# PRELIMINARY INFORMATION SHEET (BRIDGE)

PROJECT NAME: **WAITSFIELD**  
 PROJECT NUMBER: **BF 013-4(39)**  
 FILE NAME: z12b136quantity.xlsm PLOT DATE: 10/13/2015  
 PROJECT LEADER: R.YOUNG DRAWN BY: S. MERKWAN  
 DESIGNED BY: VTRANS/D.KULL CHECKED BY: T.KENDRICK  
**PRELIMINARY INFORMATION SHEET 1** SHEET 2 OF 69

REV	DATE	DESCRIPTION
	10/13/2015	NOTE REVISIONS

**RETAINING WALL 1 PLAN**  
SCALE: 3/8" = 1'-0"

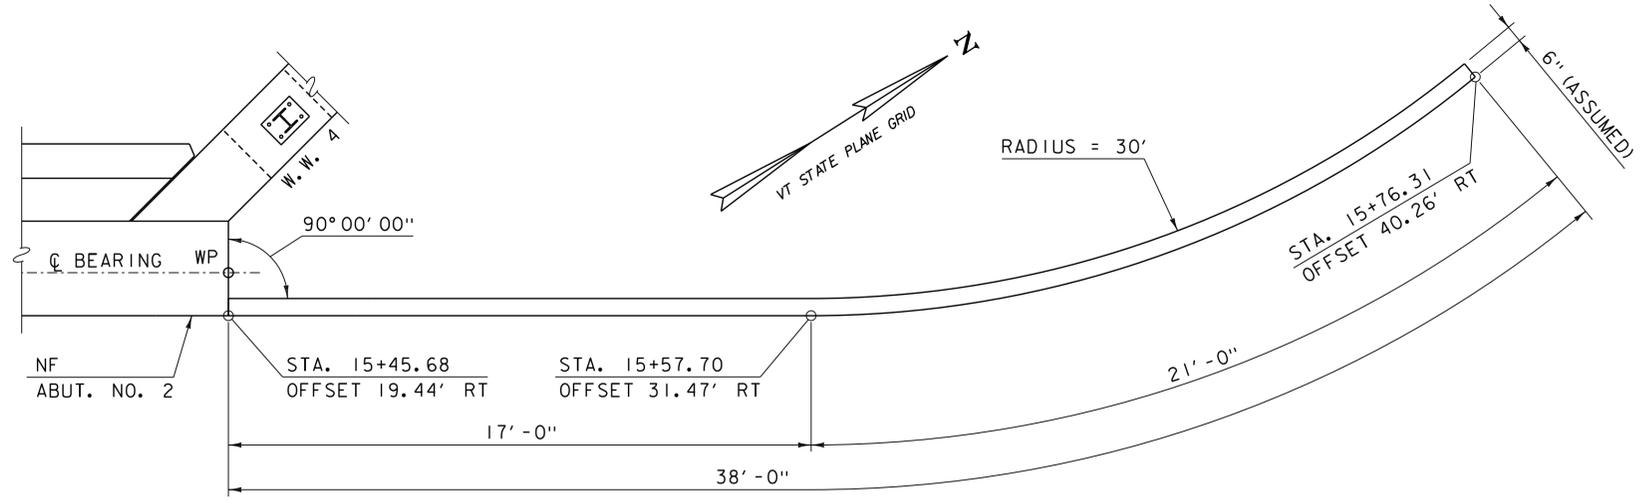
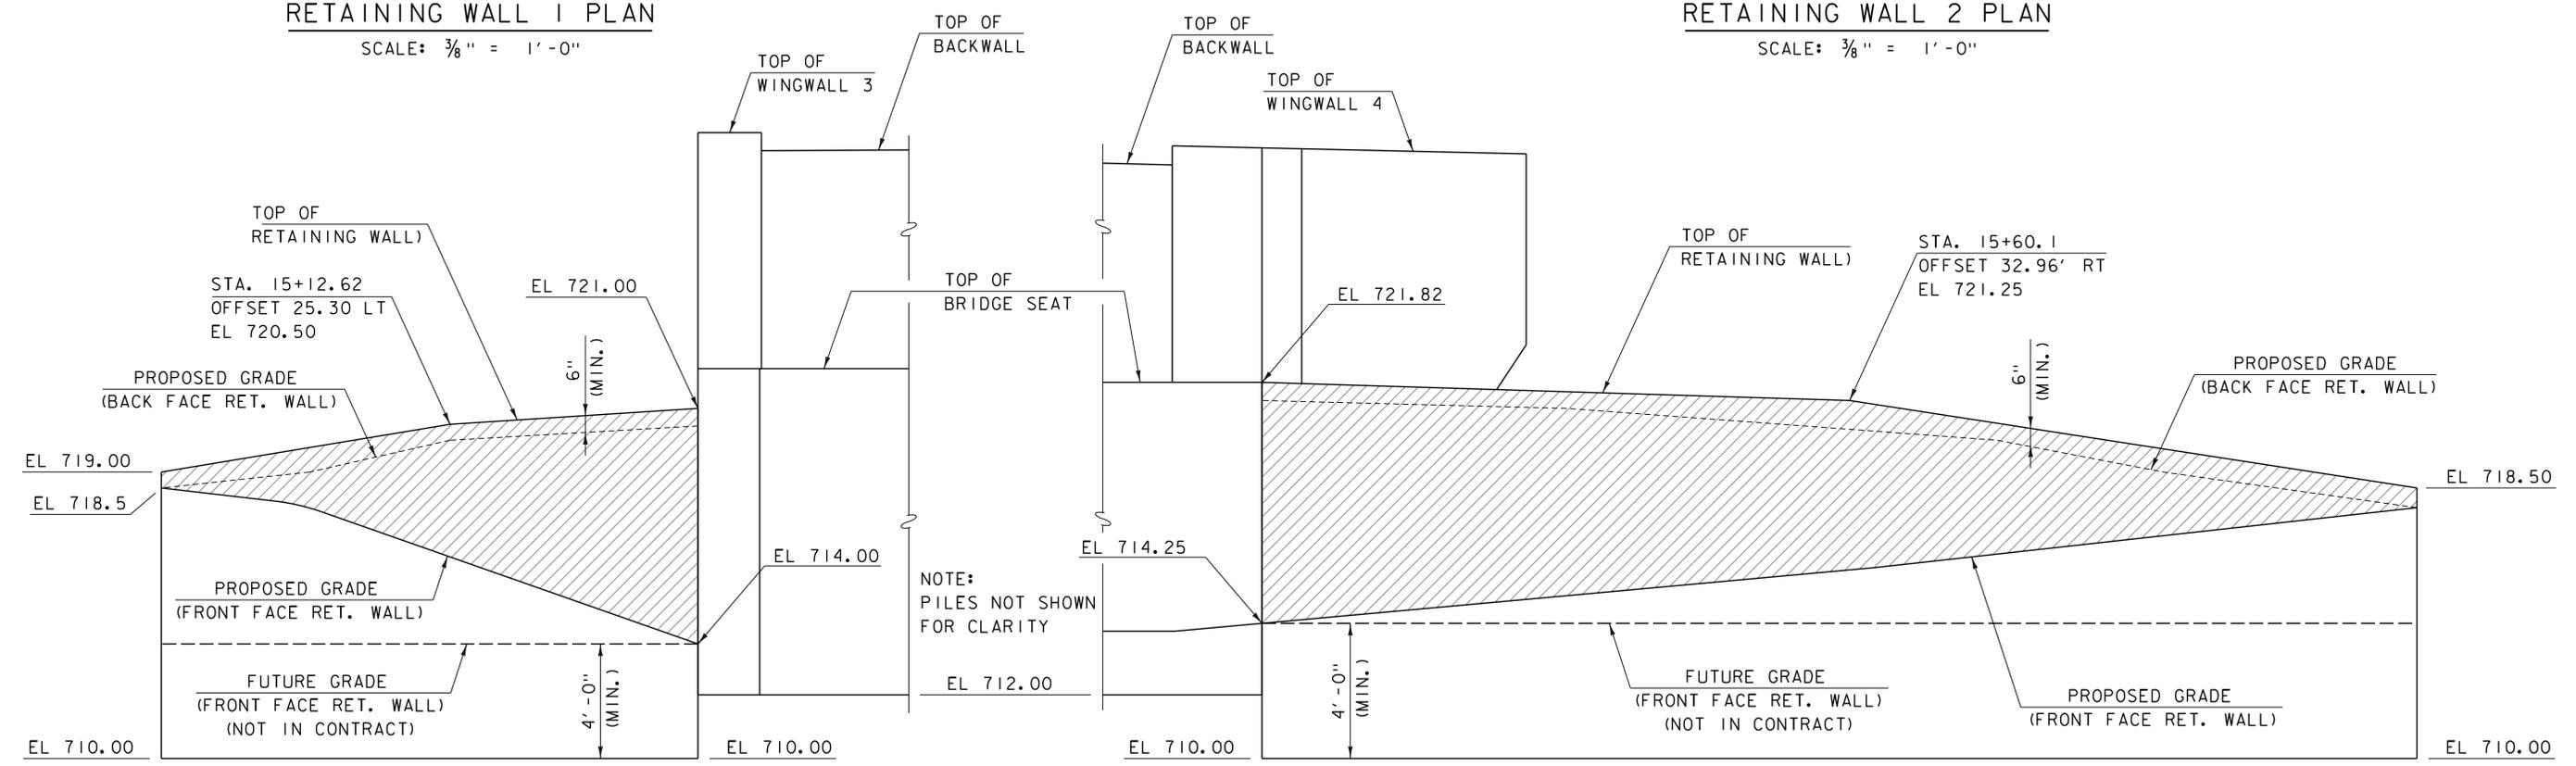
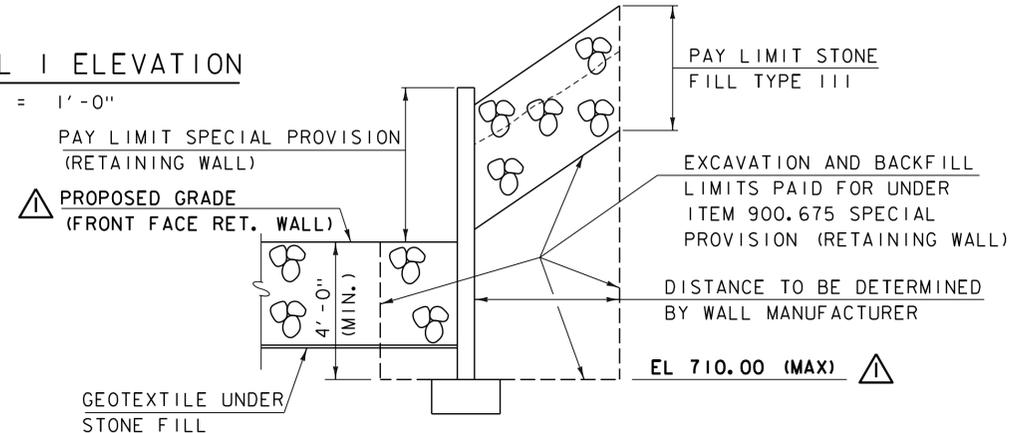
REV	DATE	DESCRIPTION
△	10/13/2015	BOTTOM OF WALL REVISION
